Applicants Response to TCB Questions

Figure 8 DL ALC/Auto Shutdown/Excessive Input Protection Image @gain 100dB

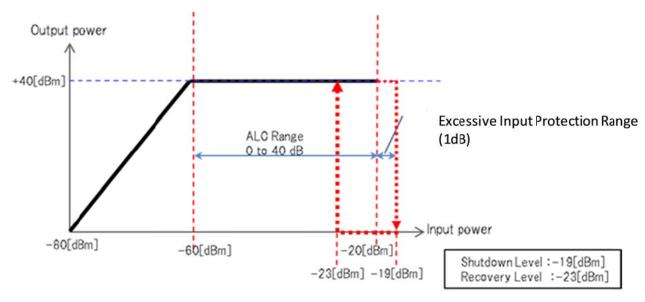
TCB Question 1: Page 6 of the report states that the device was set to operate at the 100dB gain setting, but the power measurements on page 14 show the input signal level at -20dBm and -33dBm for Downlink and Uplink and output level at 40dBm and 27dBm for Downlink and Uplink. The difference between input and output levels is 60dB, not 100dB. Please explain. Testing should be done with input signal levels of -60dBm and -73dBm.

[Response] Originally, it was tested input signal level -59.4 dBm and -72 dBm at 100 dB gain. However, on KDB 935210 what you provided, EUT should be set maximum input rating and maximum gain. So, I checked the output of -20 dBm and -33 dBm at 100 dB gain and EUT showed same output level because of Automatic Level Control function. At that time, I needed to show the output level at maximum input rating -20 dBm / -33 dBm and maximum 100 dB gain. Please refer below;

The repeater has ALC (Automatic Level Control) function. If specified input level is exceeded, **the automatic control of the attenuator** in equipment is carried out, and an output level is kept constant. Even if it exceeds a maximum input level, repeater is keeping ALC by "Excessive Input protection" function while excessive input protection range

Excessive input protection range is provided keeping maximum output power and avoid immediate shutdown by excessive input. When the repeater detects input which exceeds excessive input protection range, auto shutdown is carried out immediately.
